ADDENDUM NO. 1

Reference: Fillmore Armory Upgrade
Utah National Guard – Fillmore, Utah
DFCM Project No. 09242470

ADDENDUM # 1

PROJECT: Utah National Guard
Fillmore Armory Upgrades
Project No. - 09242470
36 W Center Street
Fillmore, UT 84631

A5
A201

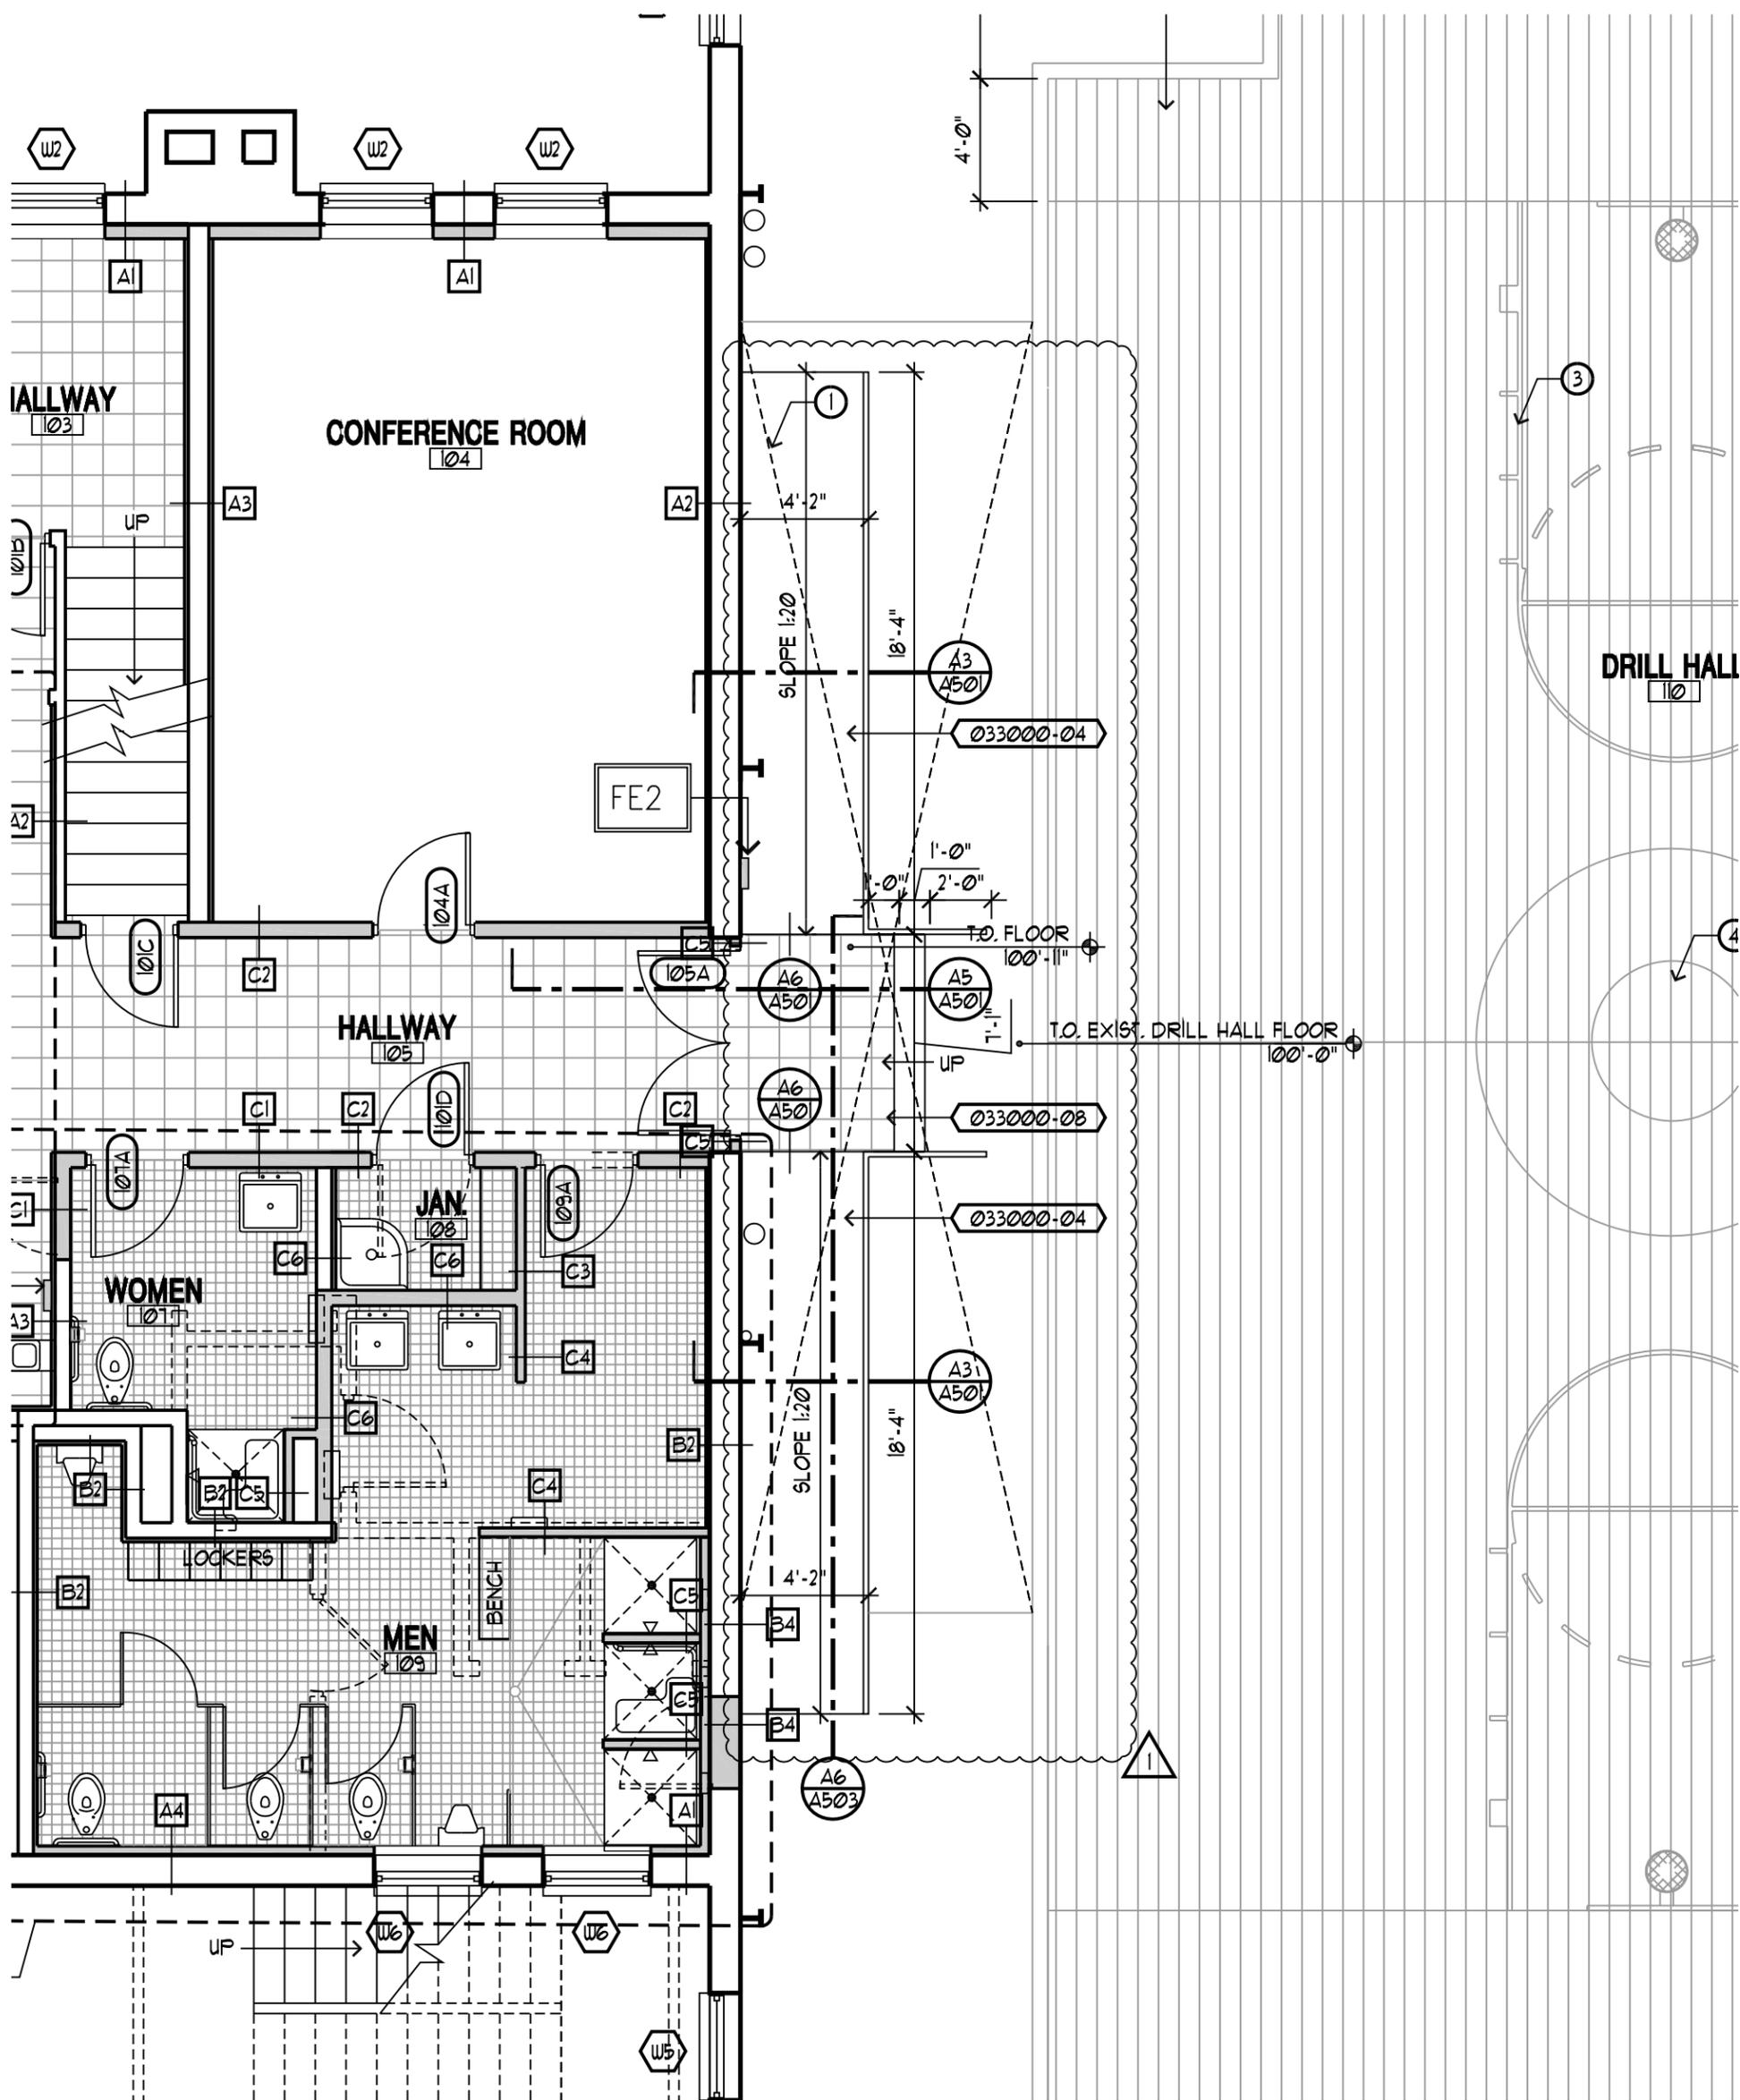
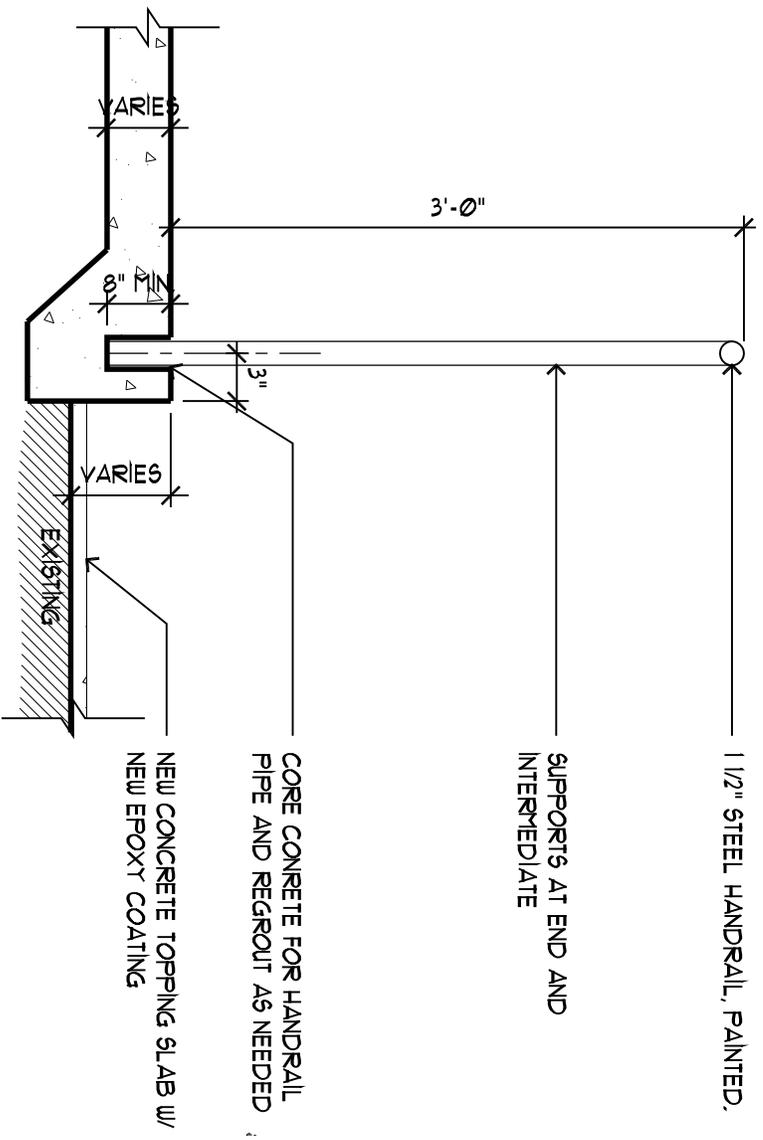
- 23.2. Elevation A5: Guardrail and Handrail from the Upper level to grade needs to be removed and replaced as per the details on A503.
24. SHEET A-501 ARCHITECTURAL DETAILS:

CURB/GUARD DETAIL

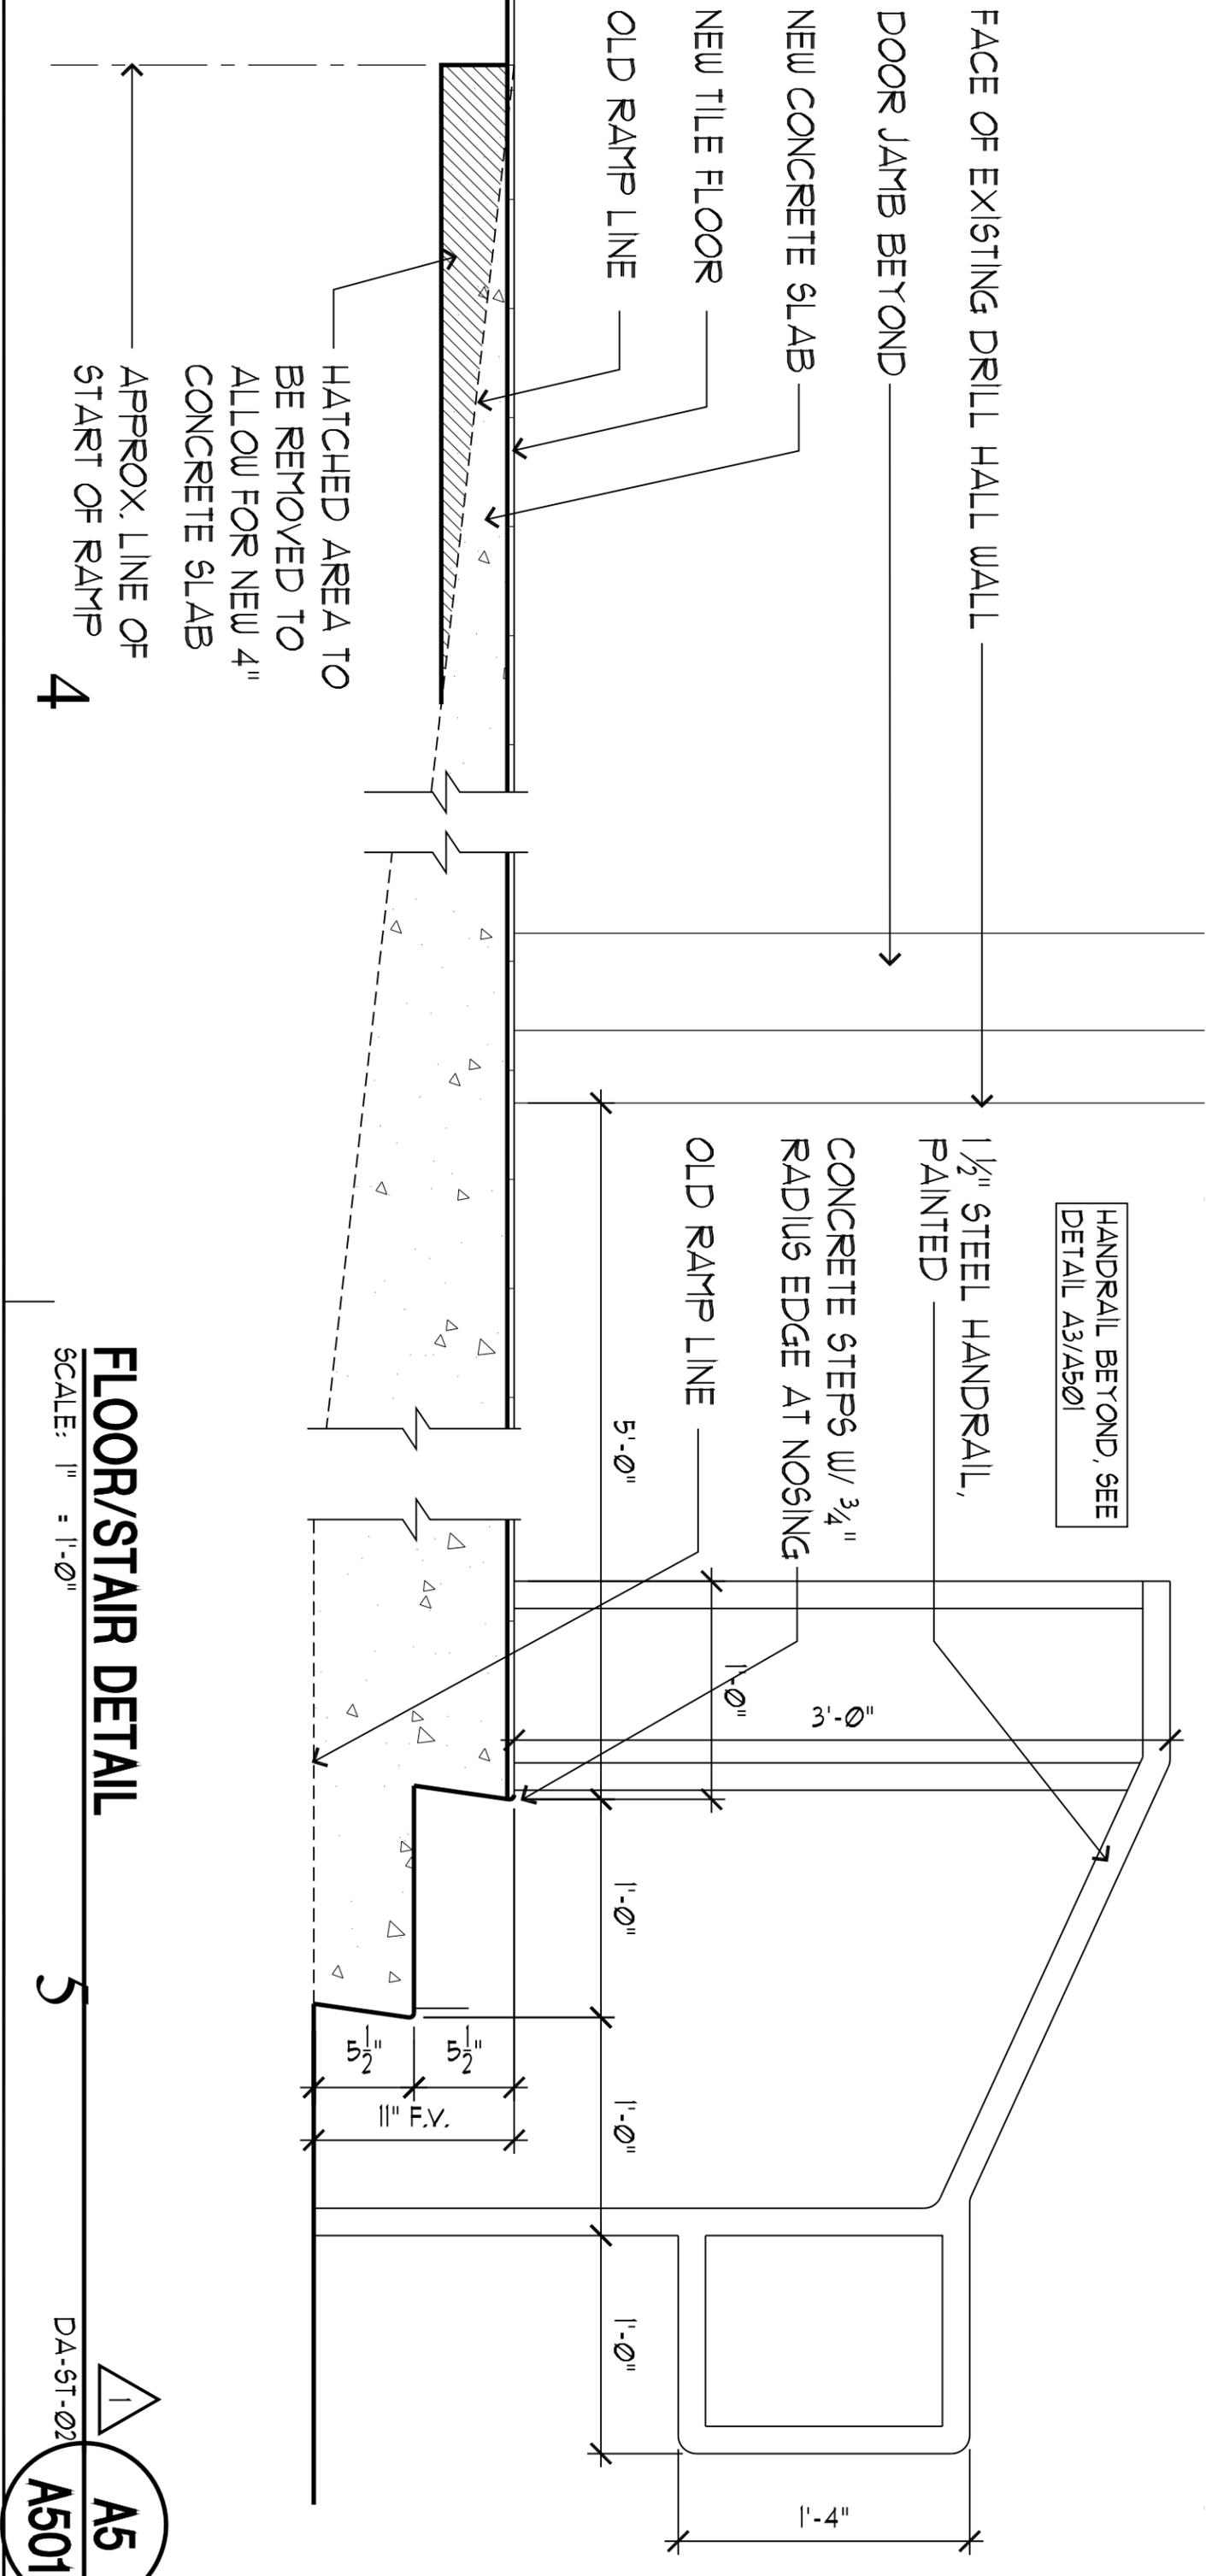
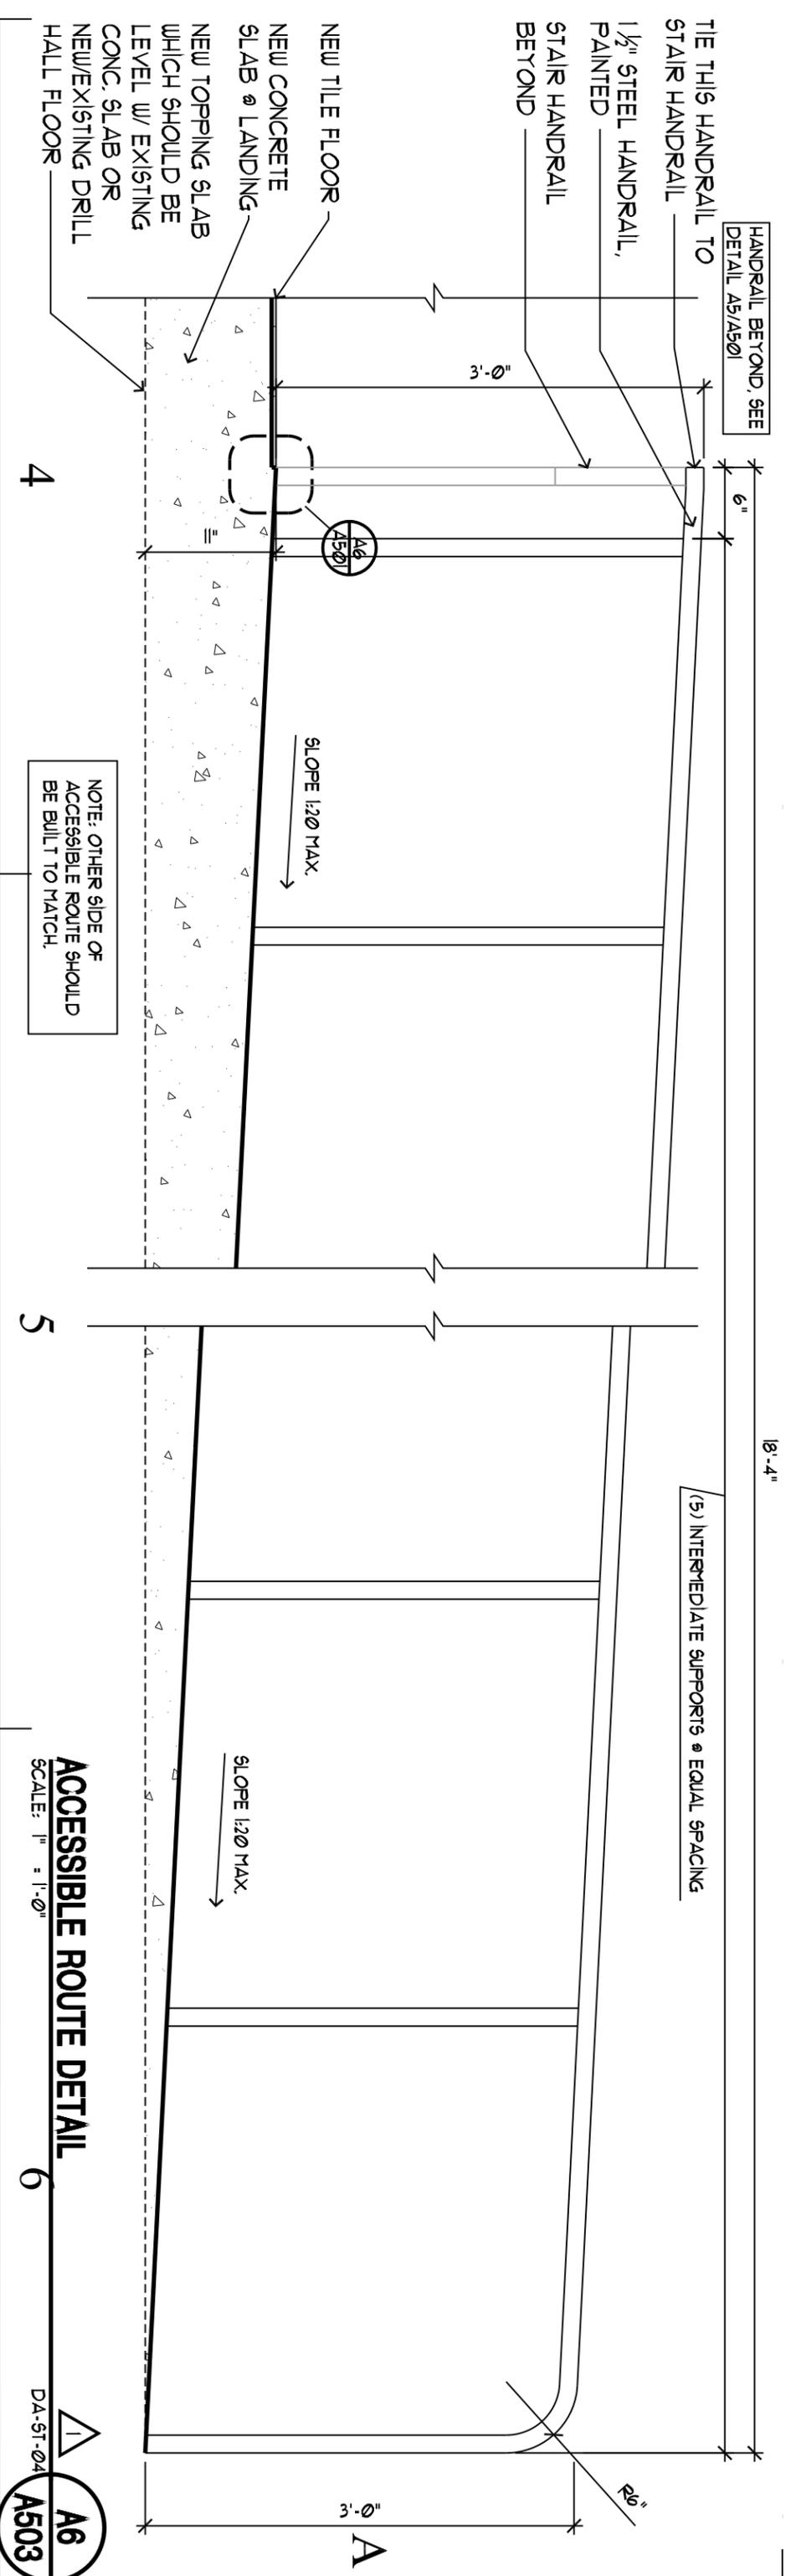
- 24.1. Detail A3 revised- see attached detail.
- 24.2. Detail A5 revised- see attached detail.
25. SHEET A-503 ARCHITECTURAL DETAILS:
- 25.1. Detail A6 added- see attached detail.
